Subject : Fixation of charging coil and lighting coil on armature plate ass'y.

Models affected : Motorised glider engine type 535, all engines of execution A, B and C.

Fig. 1

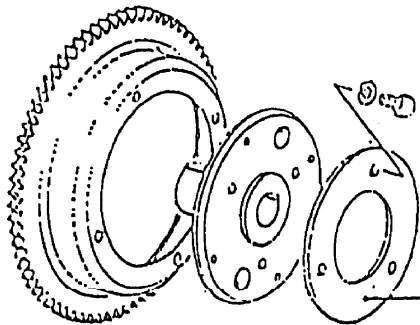
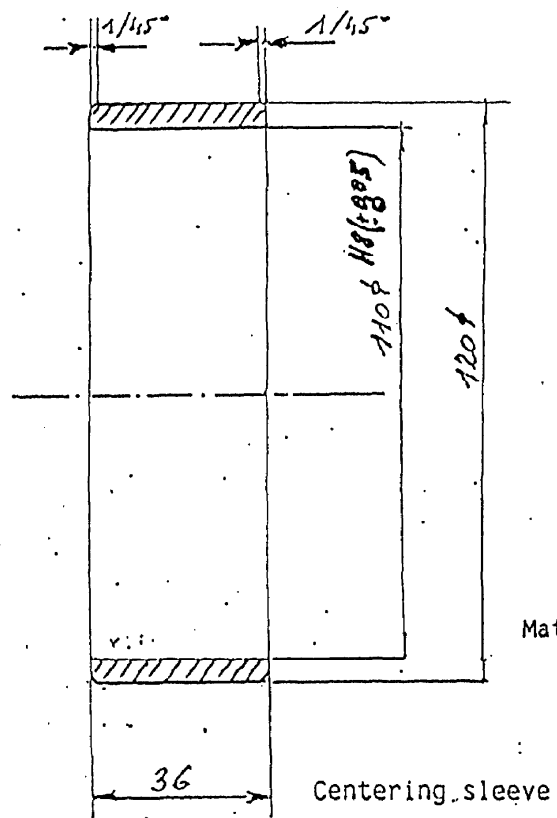
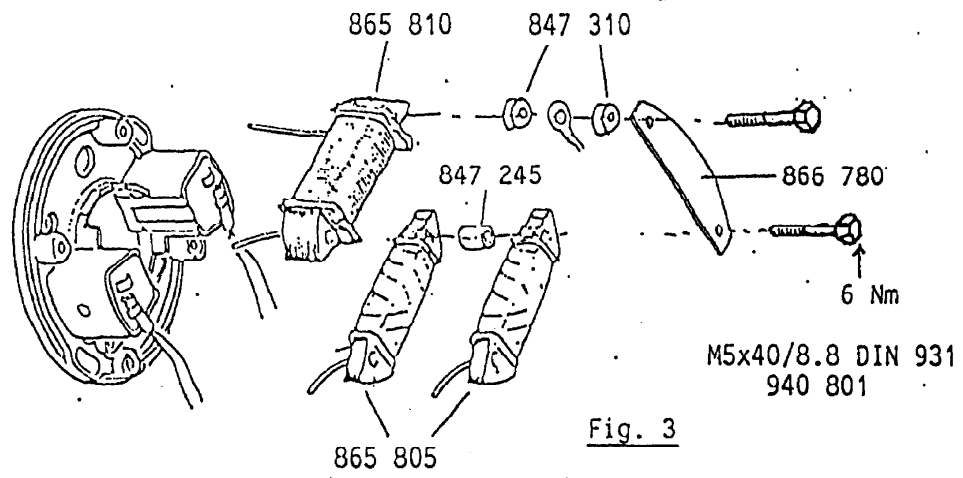
- 1.1. Remove cover washer (if existing) by unscrewing three bolts
socket spanner, size 13 A/F. Reassembly not forseen.
- 1.2. Fasten flywheel fixture (876 080) with three hex. hd. screws
M8 x 16.
- 1.3. Remove crankshaft hex. nut M22 x 1,5 with socket spanner,
size 30 A/F.
- 1.4. Place protection cap or mushroom-like protector (876.557) to
crankshaft end, fasten puller to flywheel fixture and pull
off magneto housing. Use suitable spanner, size 22 A/F.
